ADDENDUM #1
BID DOCUMENTS
1453 JEFFERSON AVENUE, DEXTER'S PHARMACY
BUFFALO, NY 14208

Addendum #1: Further masonry repairs

Figure 1

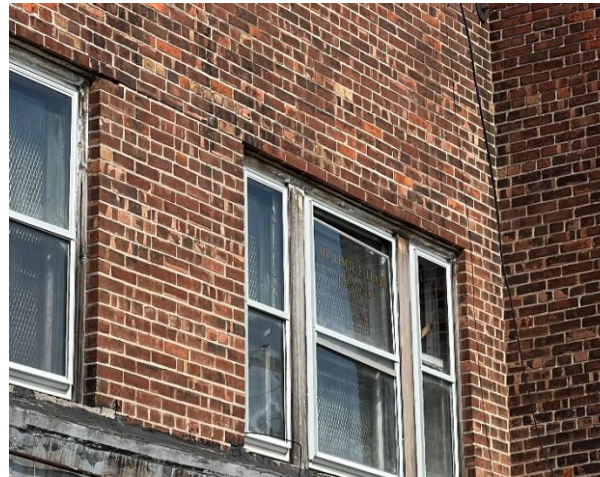
The south elevation of the building has areas that were not included in the original drawing set due to budgetary concerns. These areas show displaced brickwork and missing mortar, as a result of delamination of the steel brick angle lintels over the openings. Repairing these areas should be figured as an alternate (alternate #3, the first two alternates are listed on Sheet A-1)).

Figure replacing the steel lintels over 3 of the 5 first floor window openings and rebuilding the brickwork around the opening where it is displaced (see Figure 1). New 3 1/2" x 3 1/2" x 5/16" galvanized steel lintels shall be installed here and on the second floor at the triple window and the single window immediately to its left (Figure 2).
